Sun Microsystems, Inc. 2550 Garcia Avenuc Mountain View, CA 94043 415 960-1300 TLX 469327

March 1, 1985

Field Change Order			PCO 1037-01	Page1 of 5				
Products Affected			Level of Action Required					
Product	Serial Number	Rev.	Mandatory D Performance					
fodel 120 pedestals	C-6660 and be	lov	☐ Improvement	☐ Cosmetic

Field Change Order

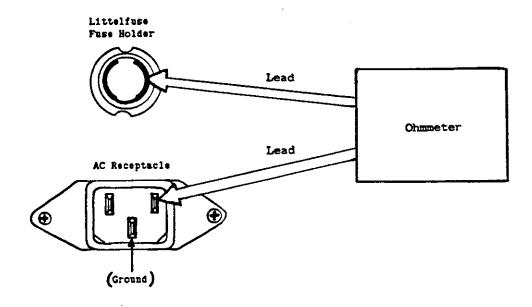
2. The Littelfuse fuse holder can be identified by the notches cut into it on the exposed section (ie., the notches can be seen without removing the cap or the fuse holder). The drawing below shows the difference between the Buss fuse holder and the Littelfuse fuse holder.

- 3. If the unit has a Buss fuse holder, the unit is good, and this FCO is not required.
- 4. If the unit has a Littelfuse fuse holder, proceed with the following steps:

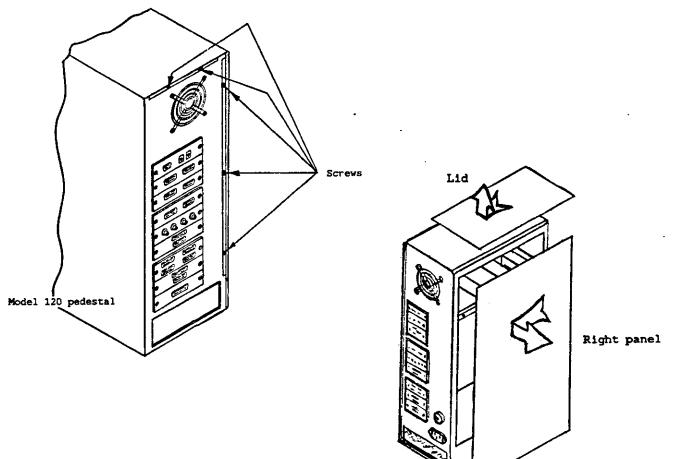
- 1. Bring the system down. ("/etc/halt")
- 2. Turn power switch to the OFF position.
- 3. UNPLUG THE AC CORD FROM THE AC OUTLET AT THE BACK OF THE PEDESTAL.
- 4. Remove the cap AND THE FUSE from the fuse holder.
- 5. Check for continuity between the fuse holder and the upper right prong of the AC receptacle as follows:

Measure resistance, placing one lead of the ohmmeter on the metal rim of the fuse holder, and the other on the upper right prong of the AC receptacle. See drawing below.

If the unit has been wired correctly, the ohmmeter should show infinite resistance.

- 6. If there is no continuity, then the unit is good.
- 7. If there is continuity (zero resistance), then the fuse holder has been miswired. Proceed with the following steps:

RE-WIRING PROCEDURE (cont'd)

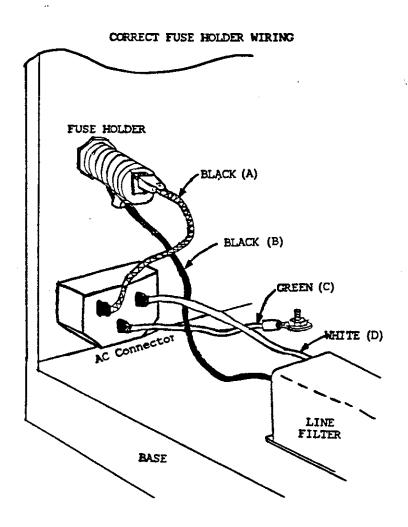
3. Compare the AC connector and fuse wiring with the drawing below showing correct wiring:

- * Black wire from AC connector should connect to rear of fuse holder. (A)
- * Black wire from the line filter should be connected to the side of the fuse holder. (B)
- * Green wire from the AC connector should be tied to chassis with a hexnut. (C)
- * White wire of the AC connector connects directly to the line filter. (D)

- 5. Re-install the fuse and the fuse cap.
- 6. Re-install the left side panel.
- 7. Re-install the lid.
- 8. Connect the power cord to the wall outlet.
- 9. Apply power to the pedestal.
- 10. Verify normal operation.
